World Forum for Harmonization of Vehicle Regulations**Working Party on Lighting and Light-Signalling****Eighty-second session**

UN Regulation No. 48 (Installation of lighting and light-signalling devices):**Proposals for new series of amendments to UN Regulation No. 48****Proposal for a new 07 series of amendments to UN Regulation No. 48****Submitted by the expert from the Special Interest Group***

"Arrangements of approval marks

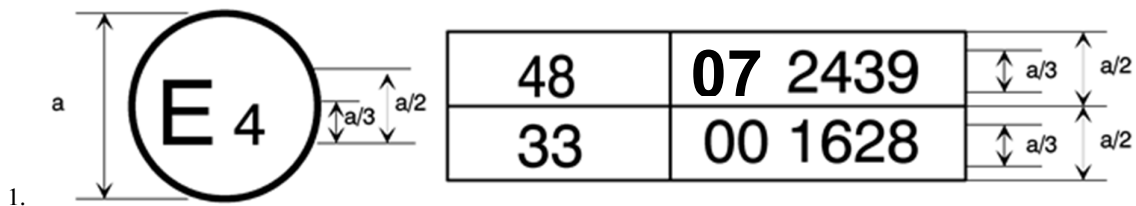
Annex 2, amend to read:

The above approval mark affixed to a vehicle shows that the vehicle type concerned has, with regard to the installation of lighting and light-signalling devices, been approved in the Netherlands (E 4) pursuant to UN Regulation No. 48 as amended by the 07 series of amendments. The approval number indicates that the approval was granted in accordance with the requirements of UN Regulation No. 48 as amended by the 07 series of amendments.

The above approval mark affixed to a vehicle shows that the vehicle type concerned has been approved in the Netherlands (E 4) pursuant to UN Regulation No. 48 as amended by the 07 series of amendments and UN Regulation No. 33.⁵ The approval number indicates that, at the dates when the respective approvals were given, Regulation No. 48 was amended by the 07 series of amendments and Regulation No. 33 was still in its original form.
